# RotorSport UK Ltd

## Service Bulletin

**SB No.: 039 issue 1**

Aircraft type & model  
(applicability)  
RotorSport UK Calidus

Calidus installation ready for removal

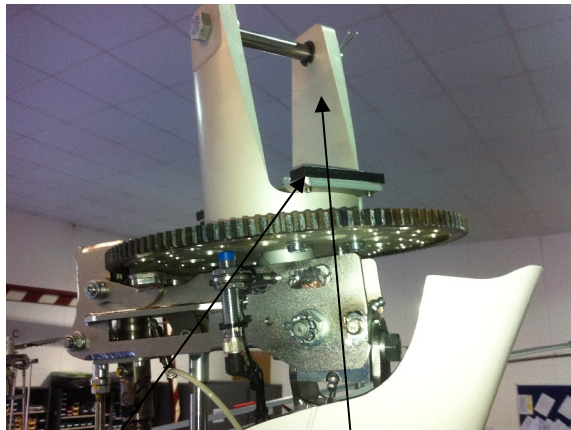
Original 18.8mm teeter-stop

Rotorsystem II 7mm teeter-stop. Note the 30mm taller tower.

The different teeter-towers and teeter stops.  
Rotorsystem II (red end-caps) is used with the taller tower shown on the left  
An original rotor (orange end-caps) must NEVER be fitted to the taller tower

19mm conical spacers either side of pitch control cable

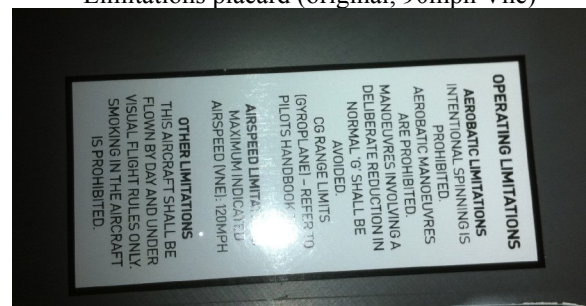
6. Refit the pitch control cable. In place of the damper rod-end a new 19mm conical spacer is used and this is provided in the conversion kit. It should be installed along with the original 19mm conical spacer as shown in the photograph below. Use Loctite 243 and a new nyloc nut (M8). Paint-mark the nut after tightening

Note: Each coned end may be dressed with a fine file (by no more than 0.1mm/.004”) in order to fit the assembly between the side-plates of the rotor bridge. Ensure that the filed surface is square to the bore.

Schematic view of Rotorsystem II. Note the different length bolts.

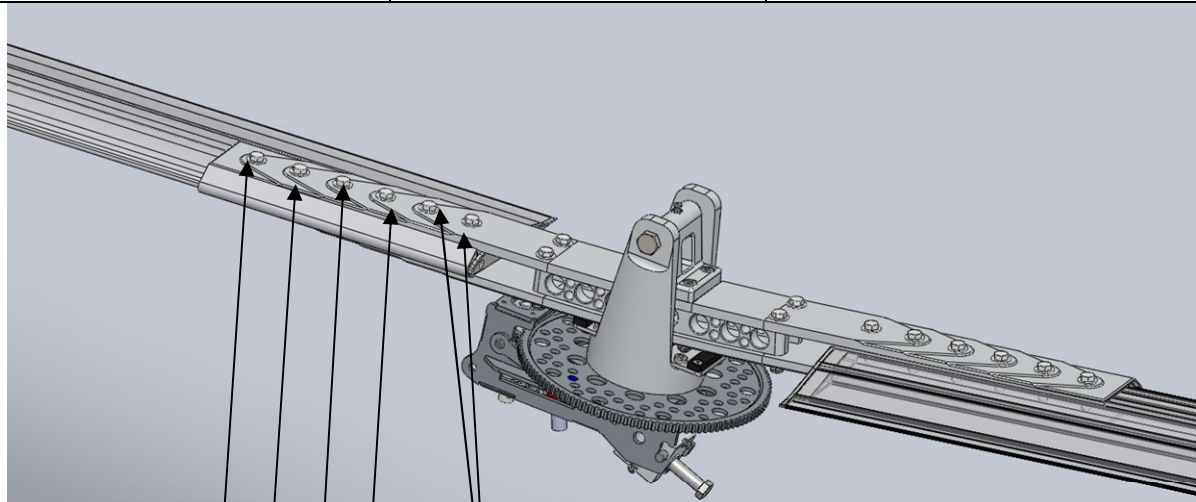
Bolt BT3697, 49mm  
Bolt BT3698, 52mm  
Bolt BT3699, 55mm  
Bolt BT3670, 58mm  
Bolt BT661, 60mm long

**WARNING!** It is important to fit the correct length bolt in the associated hole! Fitting the wrong length bolt may result in insufficient safety protrusion through the nylock nut, or that the nut jams on the shank of the bolt before the joint is properly tightened.
